NORTH ANNA POWER STATION

*Unit 1 CTS
Mark-Ups*

Improved Technical Specifications

Figure 2.1-1 REACTOR CORE SAFETY LIMITS FOR THREE LOOP OPERATION

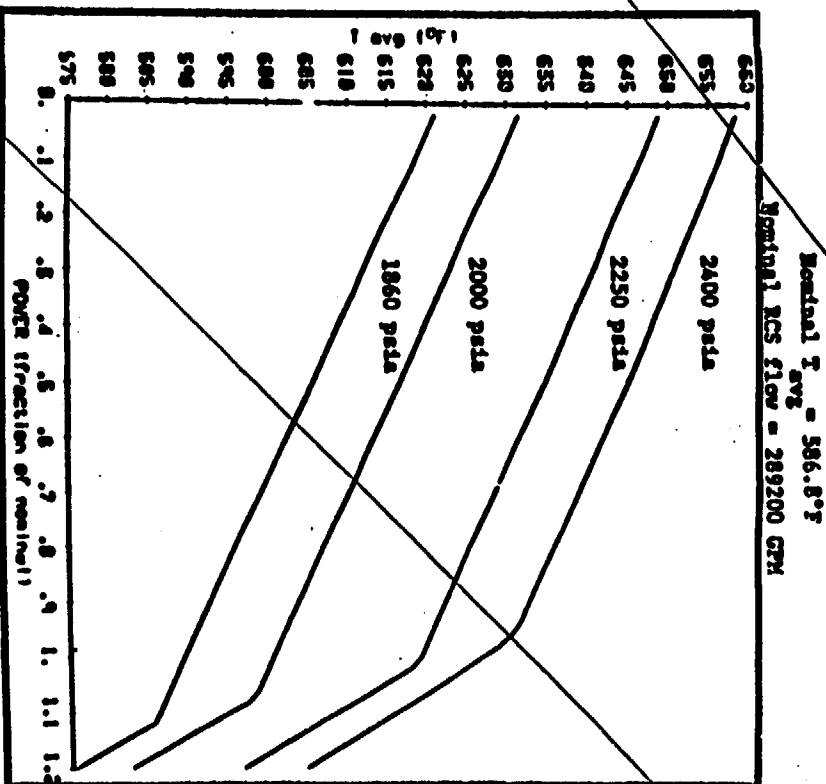
L4.1

Figure 2.1-1a REACTOR CORE SAFETY LIMITS FOR THREE LOOP OPERATION FOR THE PERIOD OF OPERATION UNTIL STEAM GENERATOR REPLACEMENT

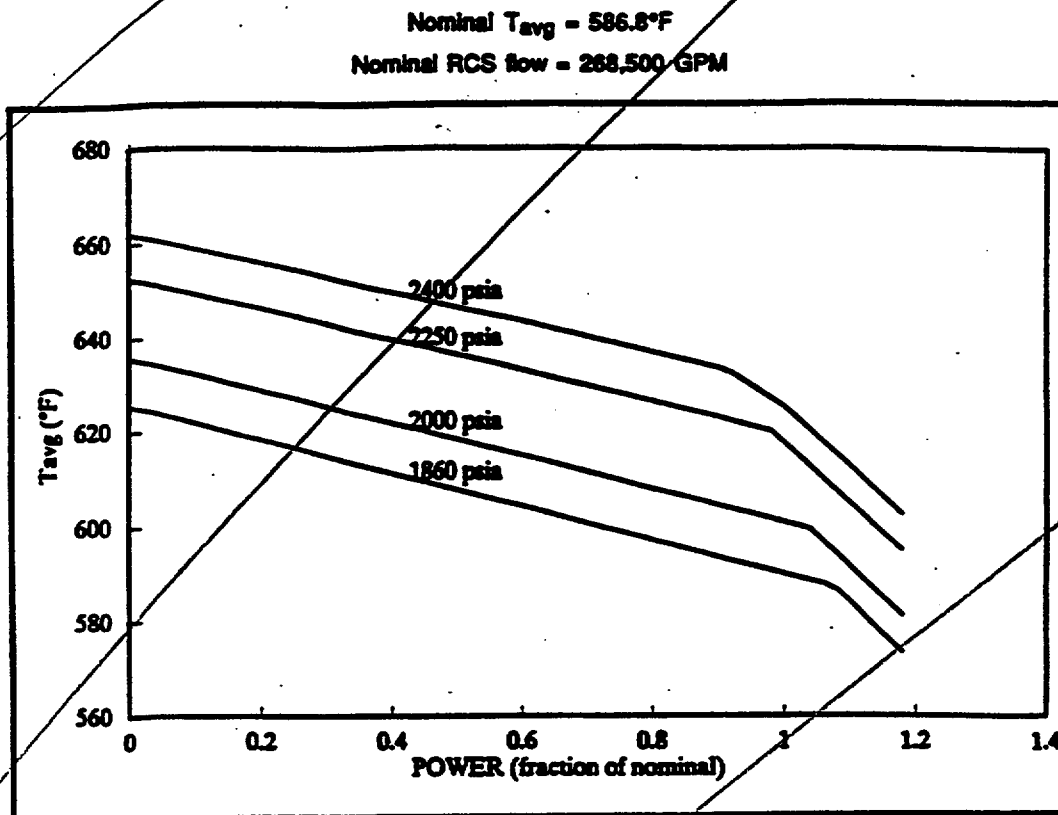
* For the period of operation until steam generator replacement, the combination of THERMAL POWER, pressurizer pressure, and the highest operating loop coolant temperature (T_{avg}) shall not exceed the limits shown in Figure 2.1-1a.

A.3

FIGURE 3.4-1

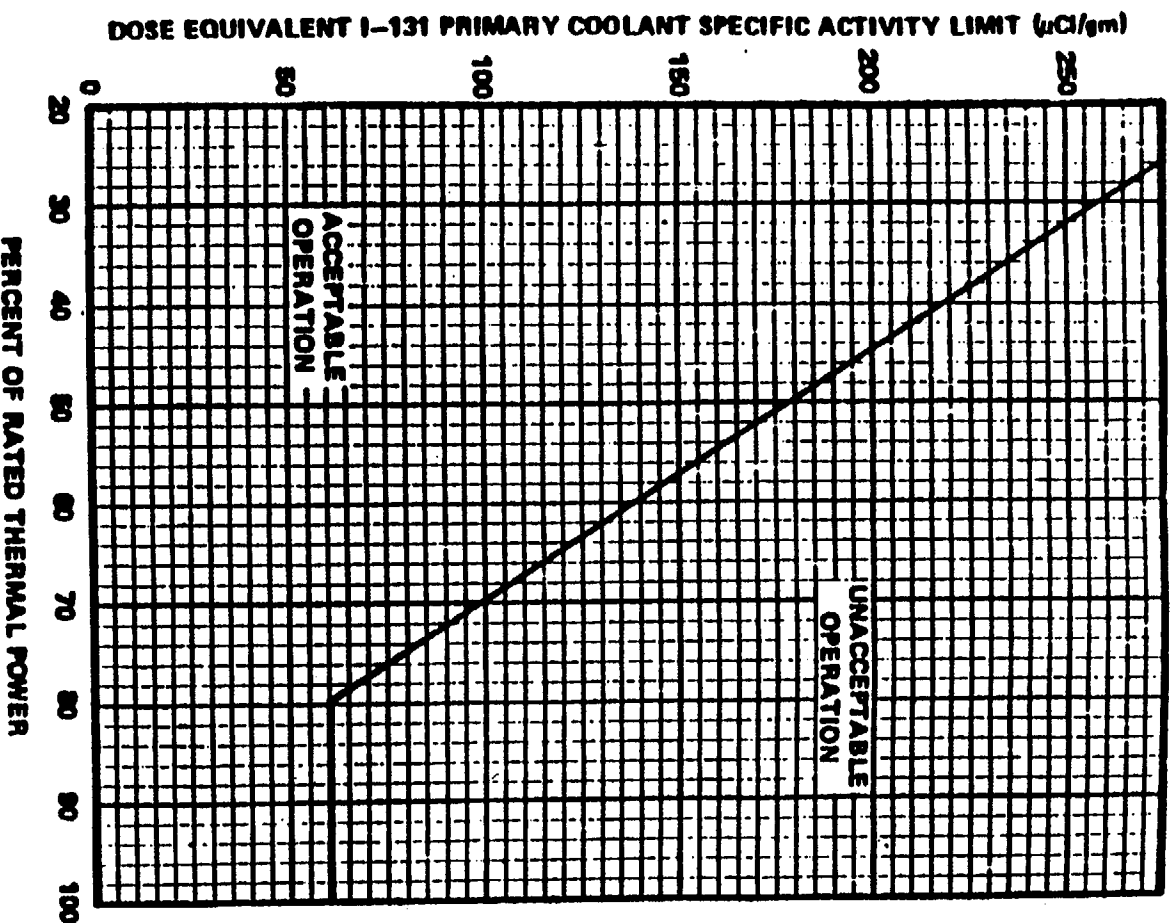
Figure
3.4.16-1
